# Staff Report

To: Salt Lake City Planning Commission  
From: Kelsey Lindquist, Senior Planner, [kelsey.lindquist@slcgov.com](mailto:kelsey.lindquist@slcgov.com) or (801) 535-7930  
Date: May 24, 2019  
Re: PLNPCM2019-00037 Green Street ADU

## Conditional Use

## **Second** BUILDING CODES PLAN REVIEW

SHEET NUMBER:  
**A-1**

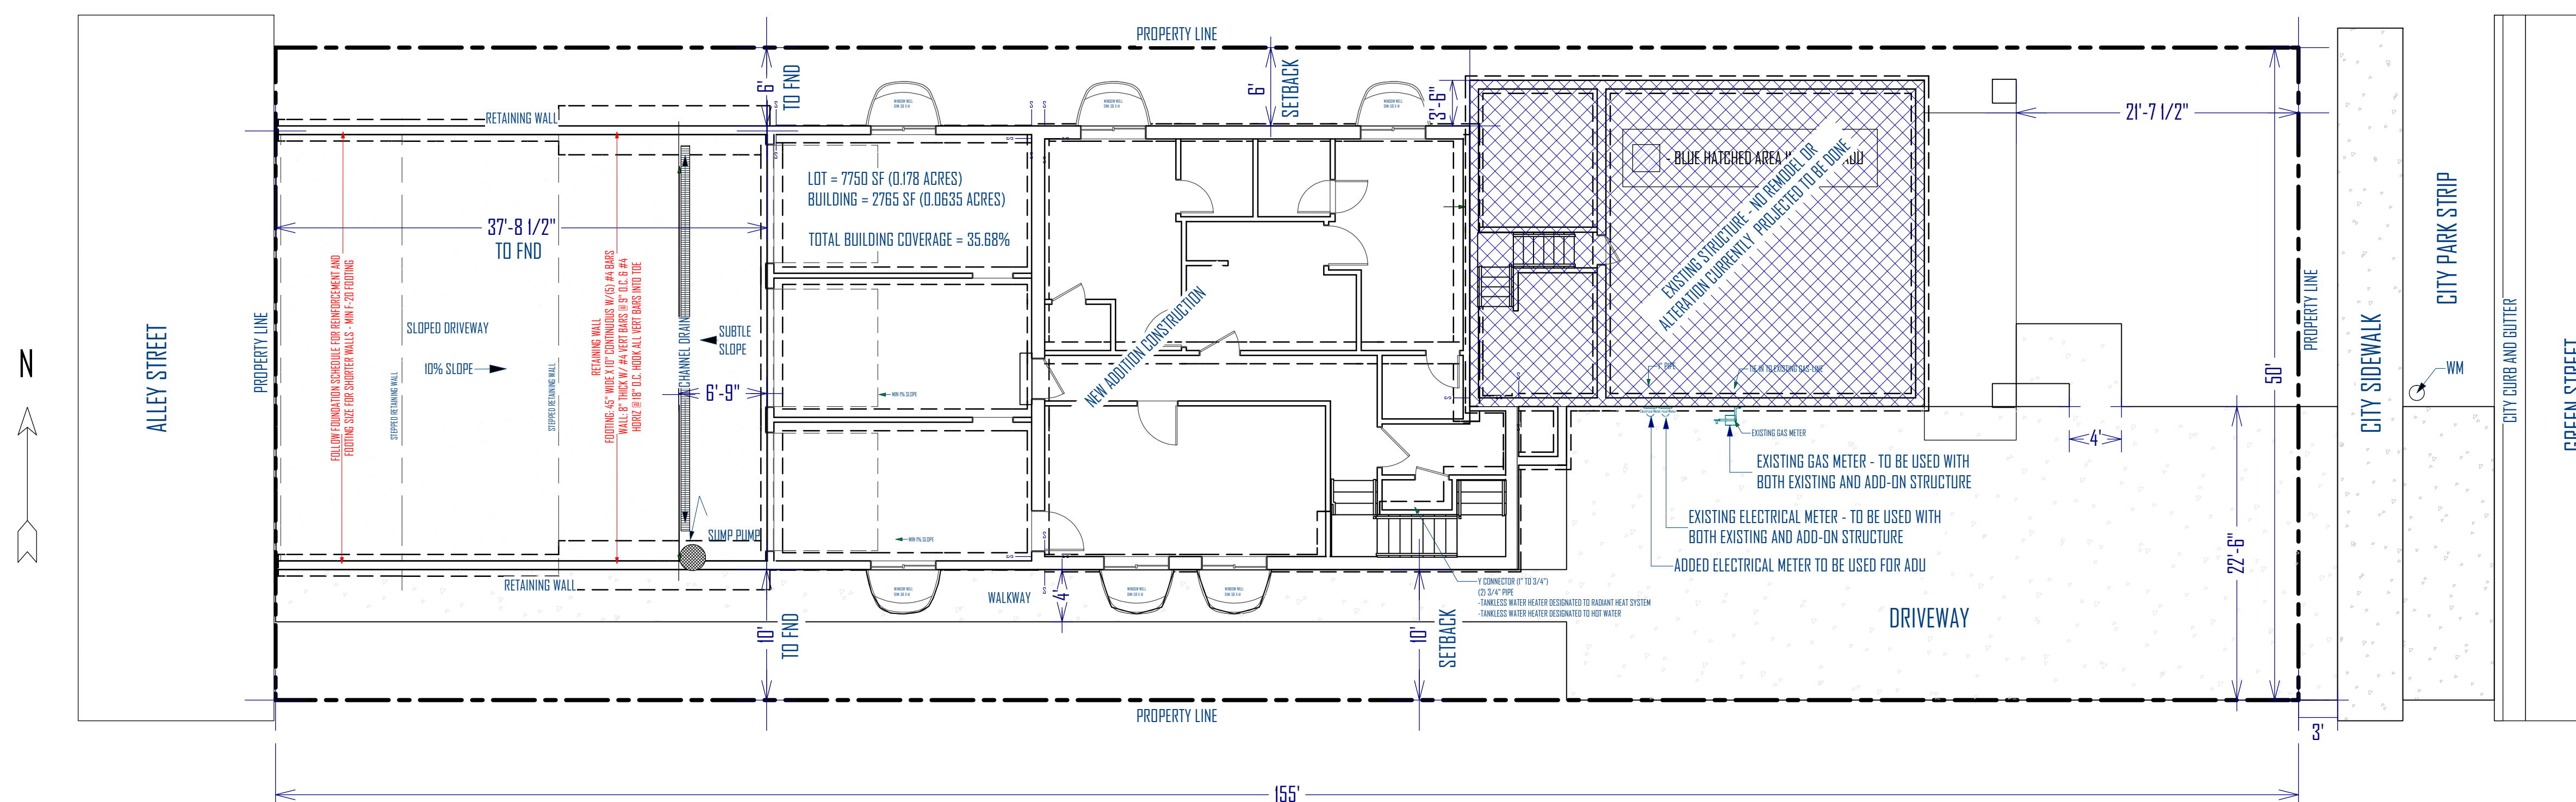
- 4. On the Cover Sheet, the revise the Area Tabulation table to list “existing dwelling” and “proposed accessory dwelling” areas to the breakdown and totals. **Resolved.**
- 5. On the site plan, please provide actual dimensions from the proposed west exterior wall and the west property line. Also add this to floor plans and the section drawings (A3.1). **Resolved.**
- 6. Demonstrate compliance with the fire separation distance and construction ratings per IRC section R302. The response states to see Keynote 10 on A-2. The keynote is there in the legend but we’re not seeing which walls have this designation.

7. On the site plan, please provide actual dimensions for the two proposed window wells. Provide the width dimension as well as the projection from the foundation wall. This dimension must be at least 3ft. to meet egress requirements. This information is shown on the 6th drawing sheet uploaded but it is also needed on the site plan.
- Please see added window wells and dimensions callouts on sheet P-2
8. On the site plan, please provide all existing and proposed utility yard line and meter locations.
- Please see added meter callouts on sheet A-1
9. Clearly indicate all existing and proposed construction. Clarify the scope of remodeling in the existing dwelling.
- See added callouts indicating existing structure and New Add-on construction on sheet A-1

**Site Plan** (sheet P-2): **Corrected to sheet A-1.**

**Michael Barry - TRANSPORTATION:** Three off street parking spaces satisfies the parking requirement. The driveway needs to sloped in 11 foot increments at a grade change of no greater the 6% per 11 feet. See <http://www.slcdocs.com/transportation/design/pdf/E2.b1.pdf> for maximum driveway slopes.

2. The maximum grade change for the new driveway at the rear of the property appears to be over 4 feet. Grade changes over 4 feet must be approved by the Planning Division as a Special Exception per Table 21A.36.020B. Submit an application to the Planning desk in room 215. Phone 801-535-7700. Provide Planning Division approval when approved.

SHEET NUMBER:  
**A-3**

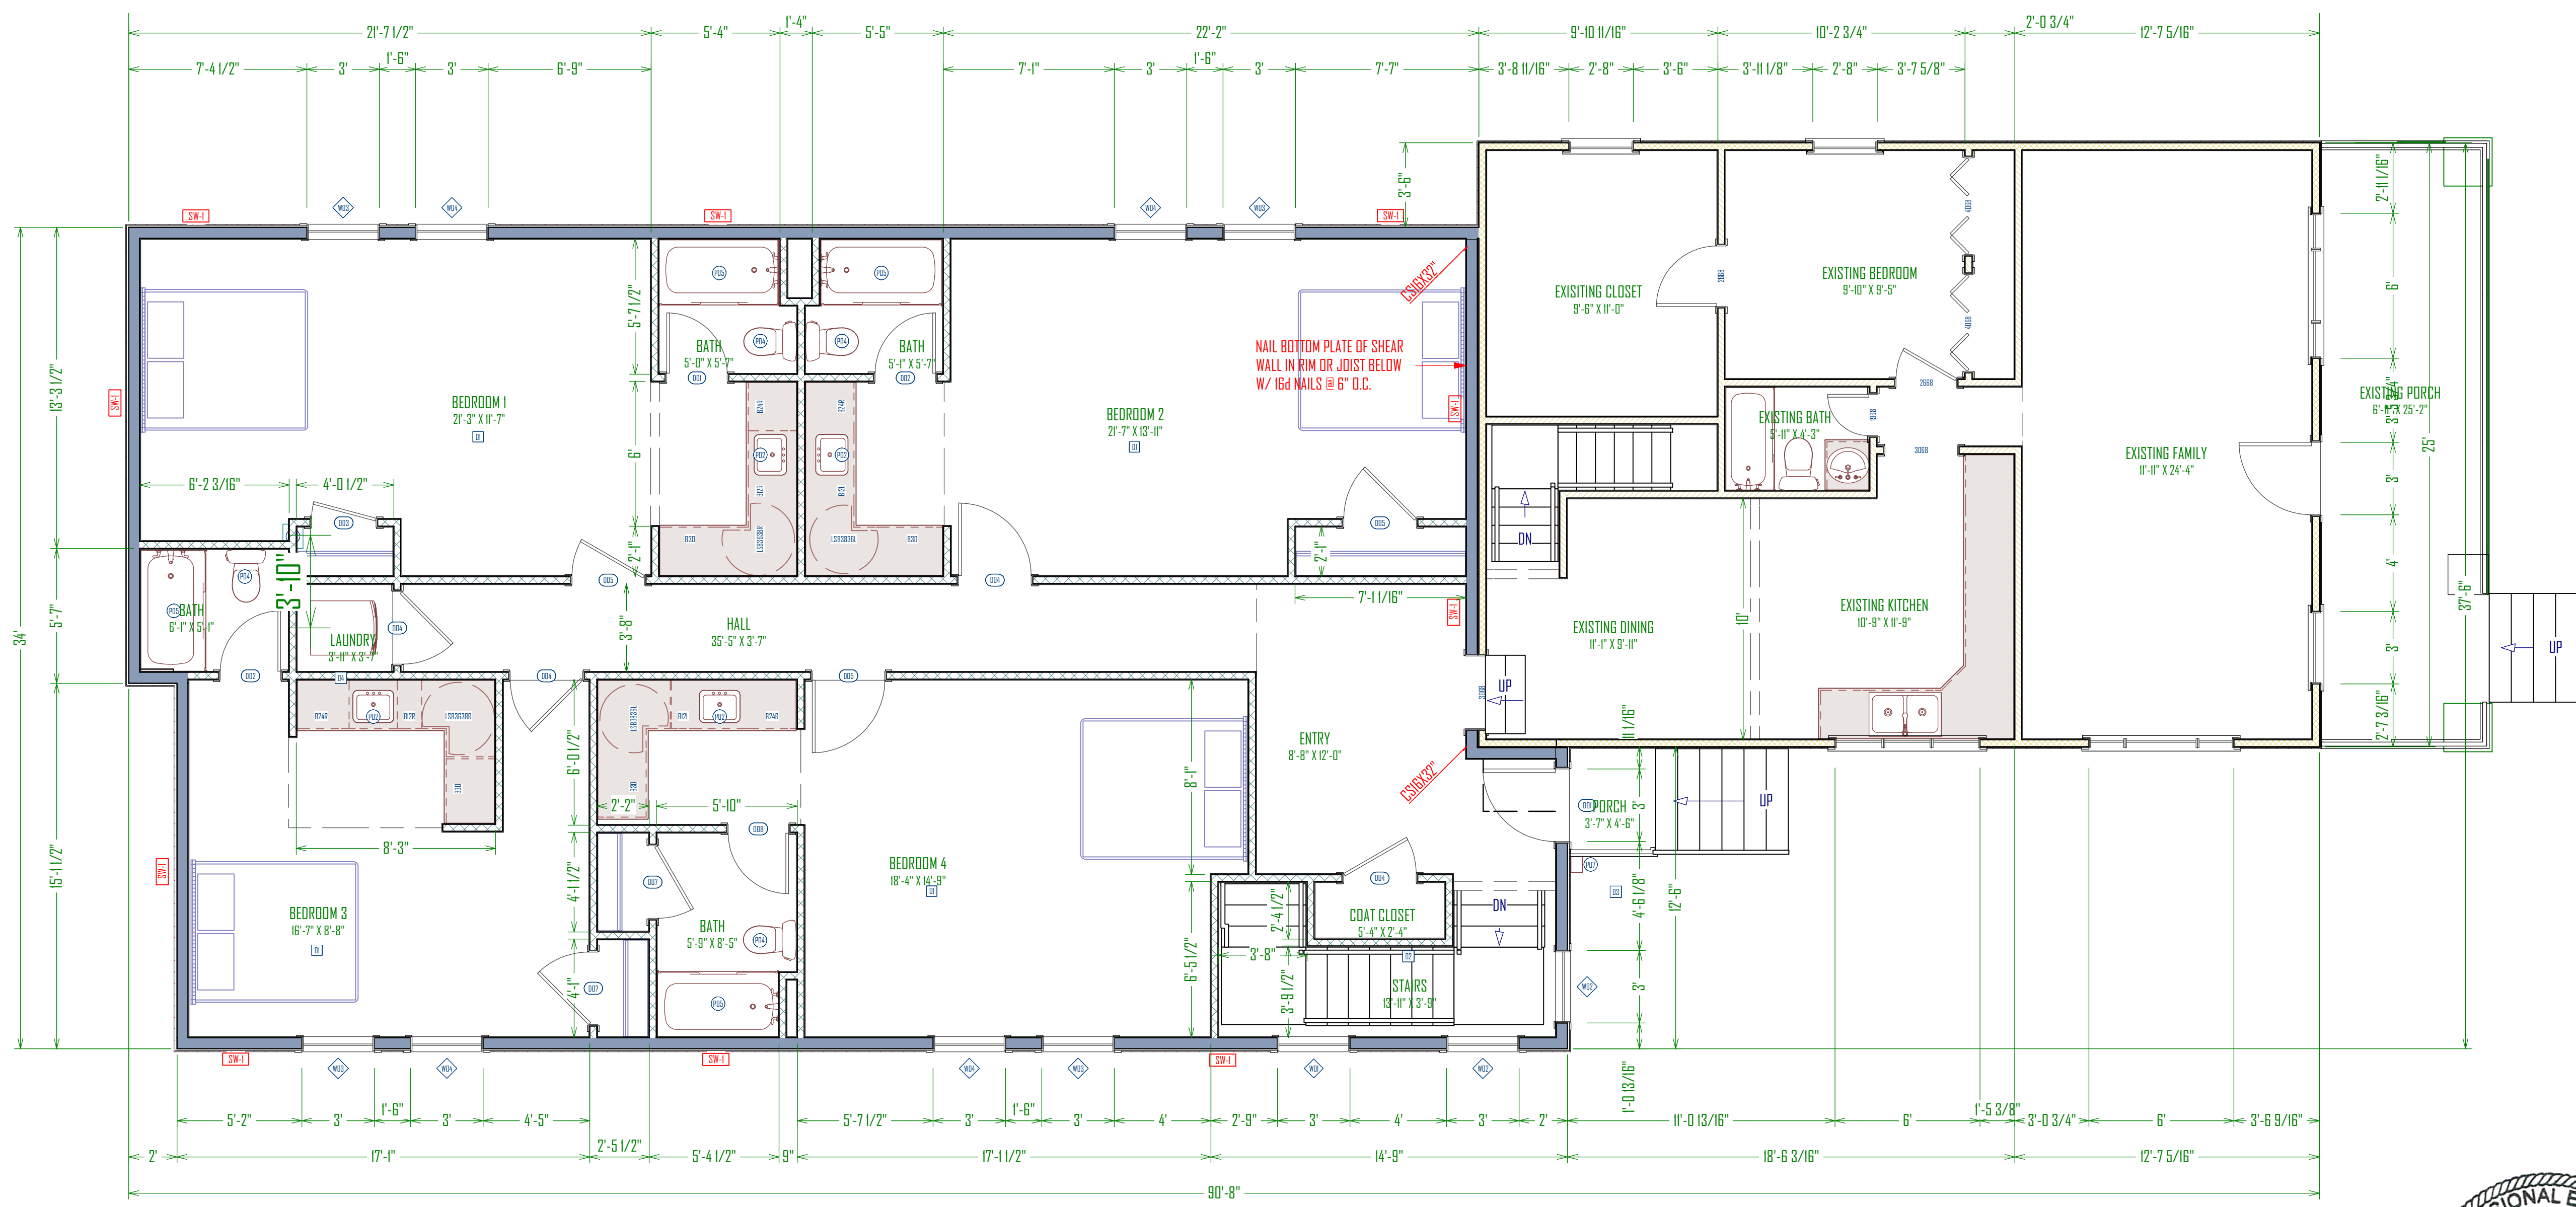
19. At the common wall on the main level, there is a pass-through (no door). Please explain the intended use of what now appears to be one enlarged dwelling. (on sheet A-3).

- No sheet is labeled "P-3". On sheet A-3 the doorway between the existing dining and entry is a passageway between these two rooms.

SHEET NUMBER:  
**P-1**

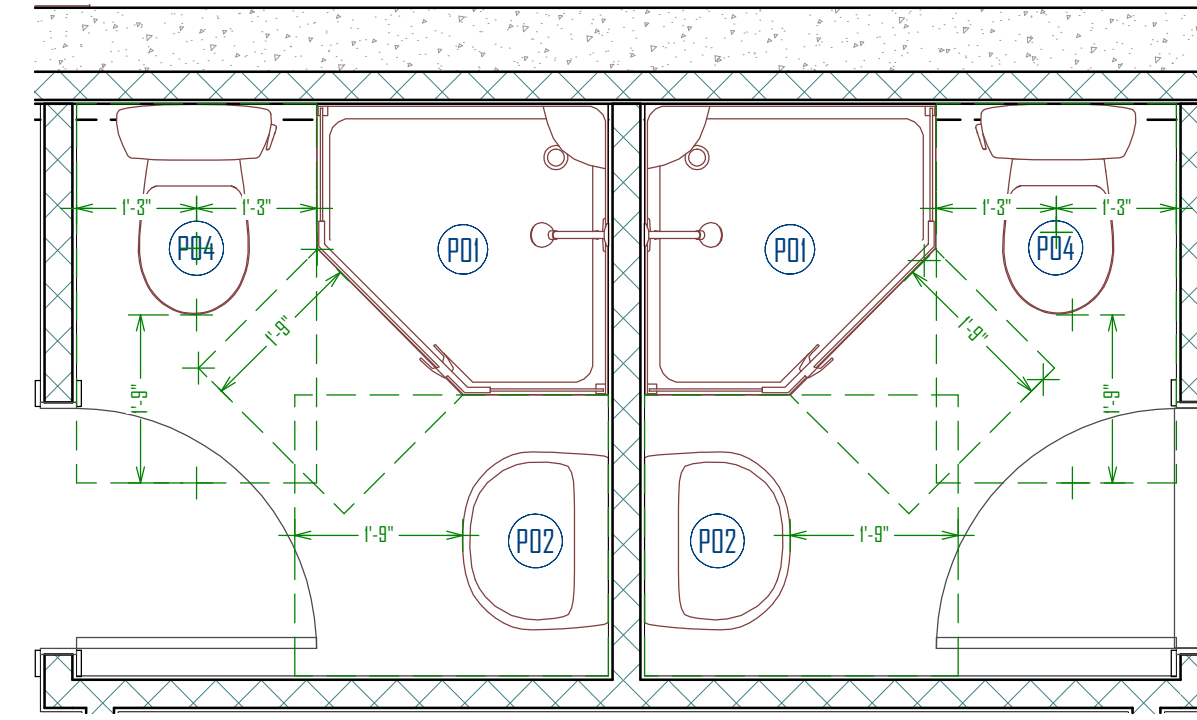
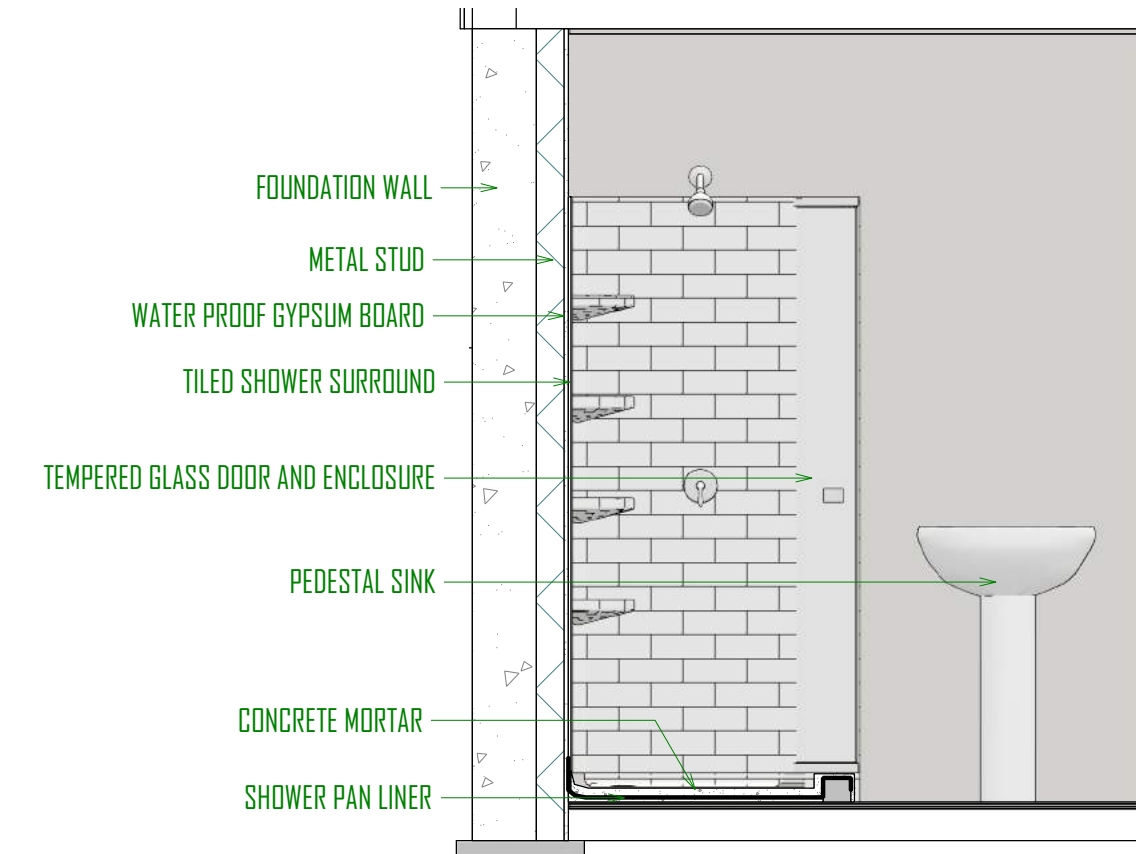
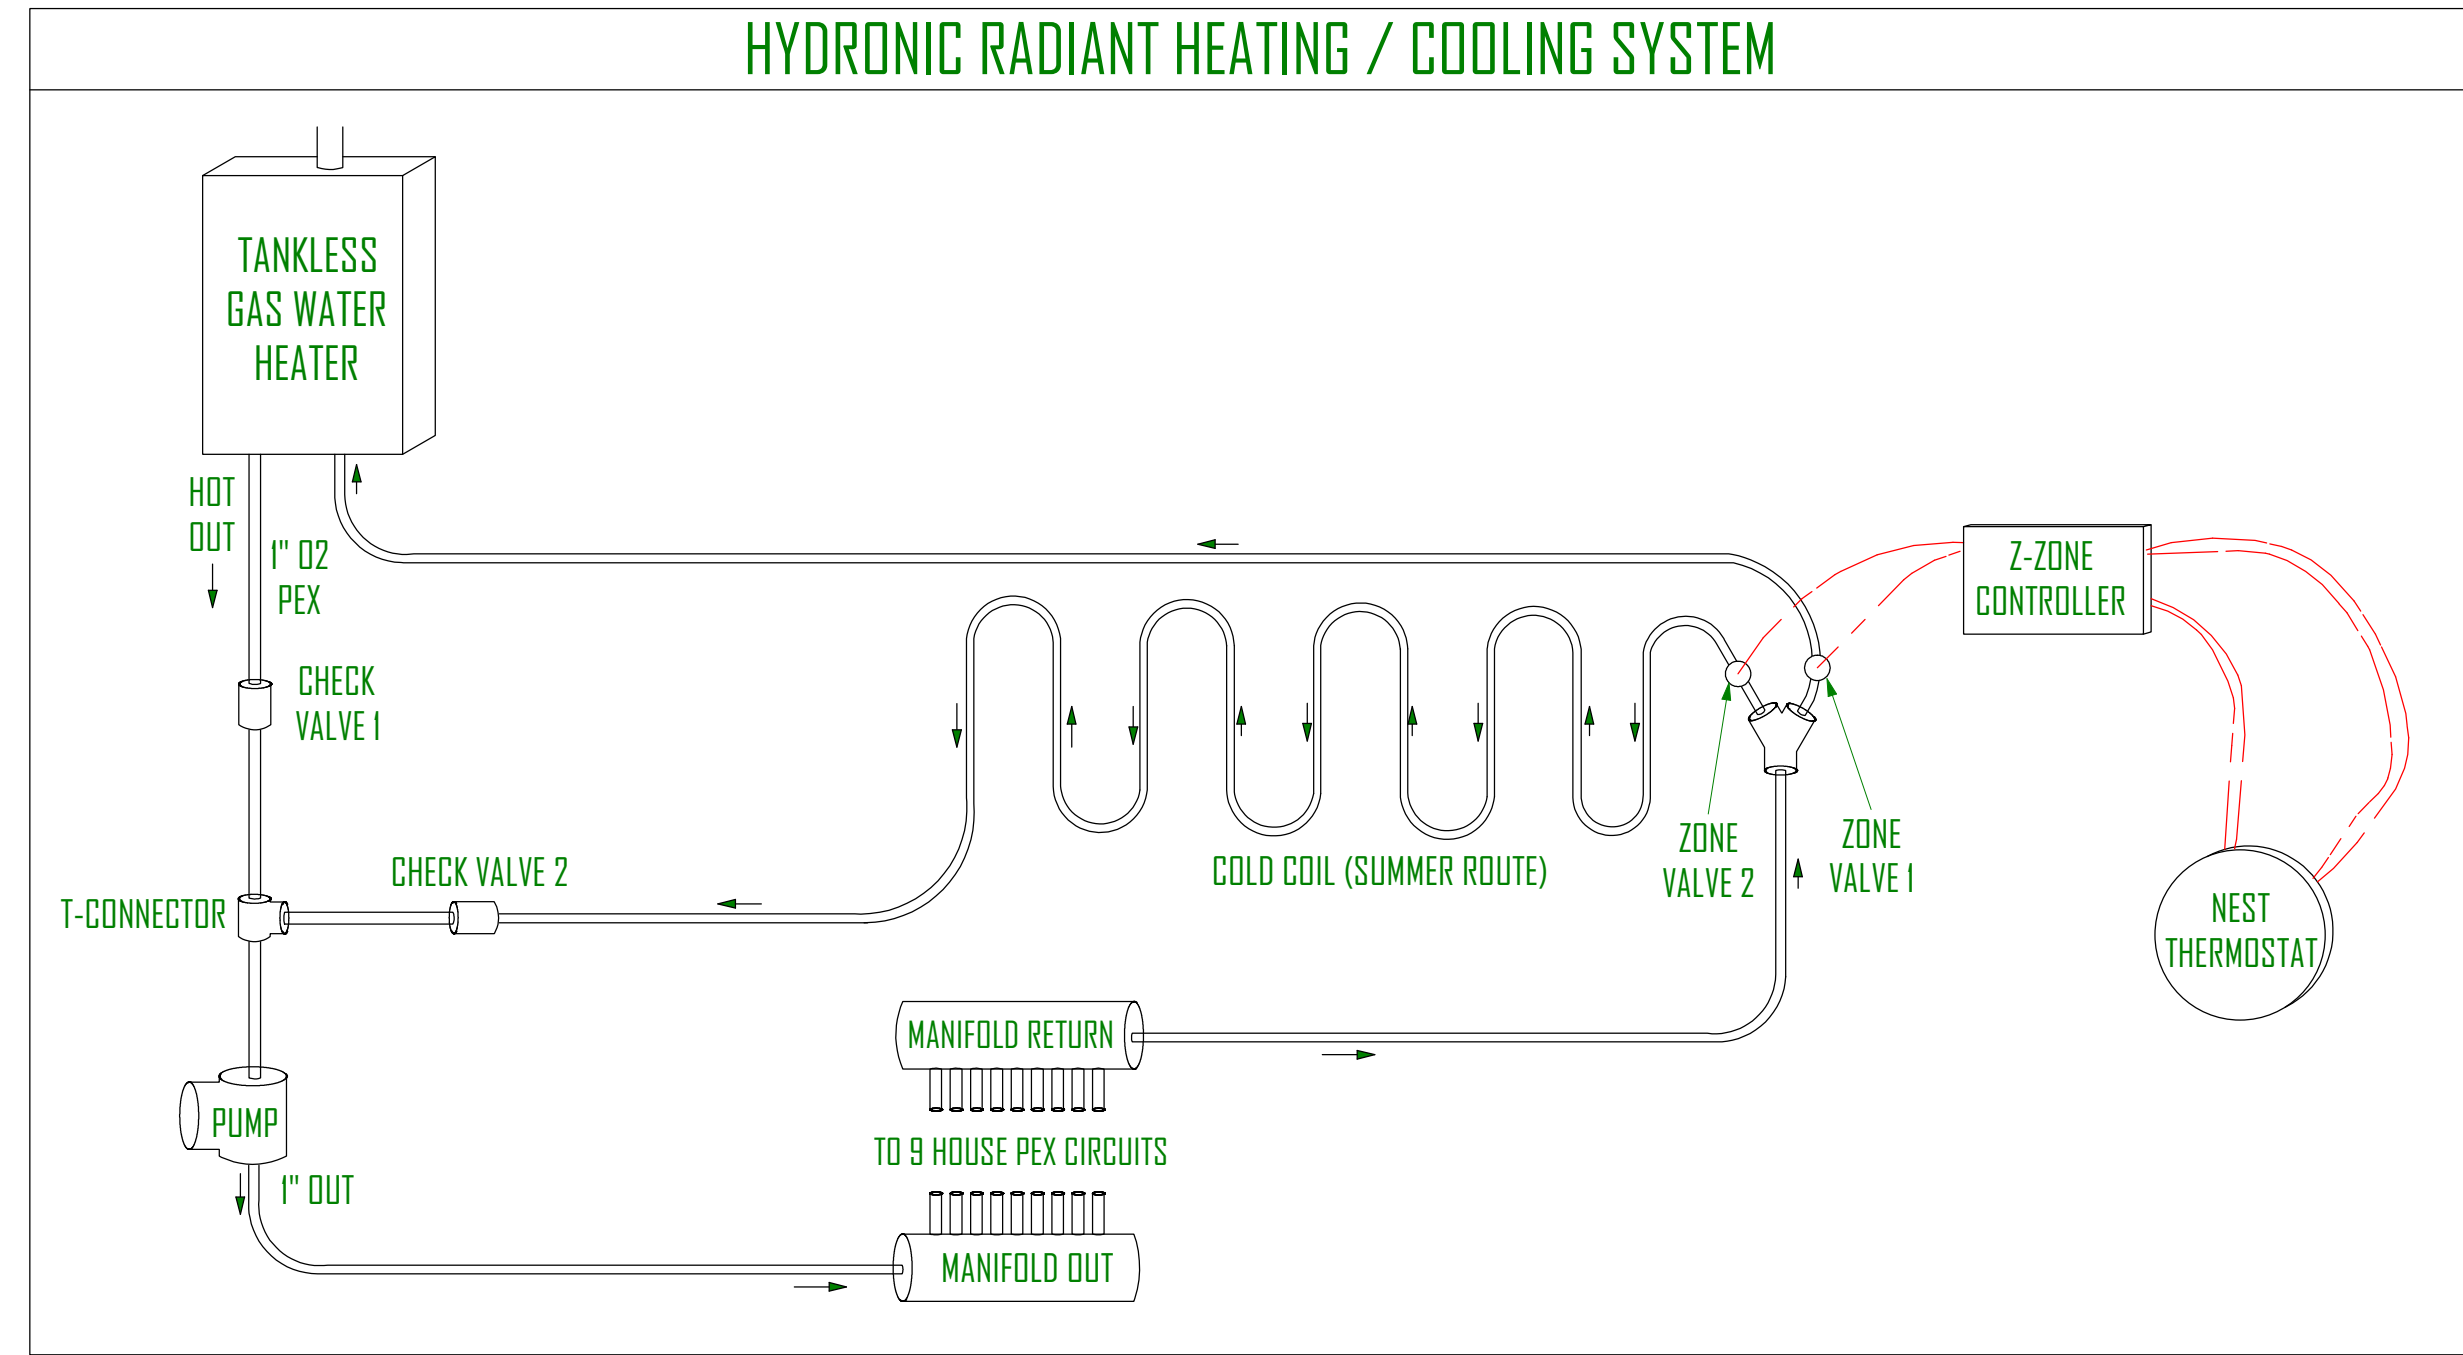
17. Enlarged bathroom plans are helpful. Please add dimensions and wall material notes (such as the tub surround wall materials). IRC Section R307.1 outlines bathroom space minimums. Also include mechanical and electrical information. **Resolved.**

17. Enlarged bathroom plans are helpful. Please add dimensions and wall material notes (such as the tub surround wall materials). IRC Section R307.1 outlines bathroom space minimums. Also include mechanical and electrical information

- See plumbing details on sheet P-1
